Superintendent
Point Reyes National Seashore
Point Reyes Station CA 94956
Attention: Giacomini Wetlands Restoration Plan

Giacomini Wetland Restoration Project

ATTN: Superintendent
Giacomini Wetland Restoration Project DEIS/EIR
Point Reyes National Seashore
1 Bear Valley Road
Point Reyes Station, CA 94956

Giacomini Wetlands restoration area:
Invasive non-native vegetation on Tomasini
Creek levee and historic railroad grade, adjacent
to Point Reyes Mesa Bluff, off Overlook Road
(near boundary of Martinelli Ranch).

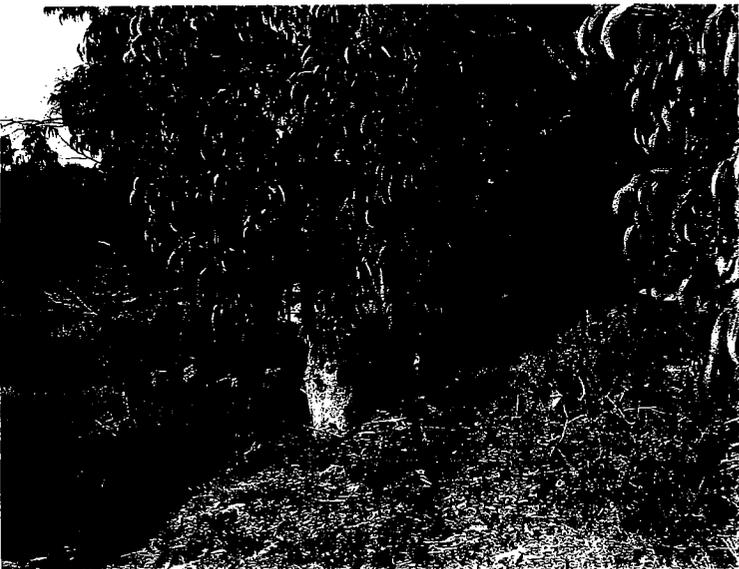
This backwater slough with its levee is retained in all planning alternatives as habitat for the endangered Tidewater Goby. Within view of my property on Point Reyes Mesa bluff, eucalyptus trees have taken root and are growing to large size on the levee itself. They may threaten the structural integrity of the levee.

On the historic railroad grade along the east side of Tomasini Creek a dense grove of eucalyptus has become established, continuing on private property ascending the bluff. French broom infestation is also extensive in this area.

Please add removal of these invasives from the Tomasini Creek levee and historic railroad grade to any restoration plan. To document this issue, a map and photos of the area described are included with this letter.

Detail from Project Area map, Giacomini Wetlands project EIS / EIR with emphasis added to pinpoint area of invasive plants on berm and historic railroad grade

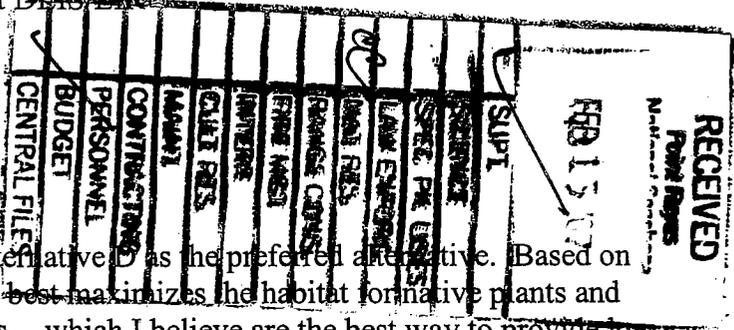
Regardless of which alternative is finally implemented, I would like to bring your attention to an area of invasive vegetation not currently identified in the project mapping that urgently needs clearing. It is along the Tomasini Creek slough, immediately south of the Martinelli Ranch.
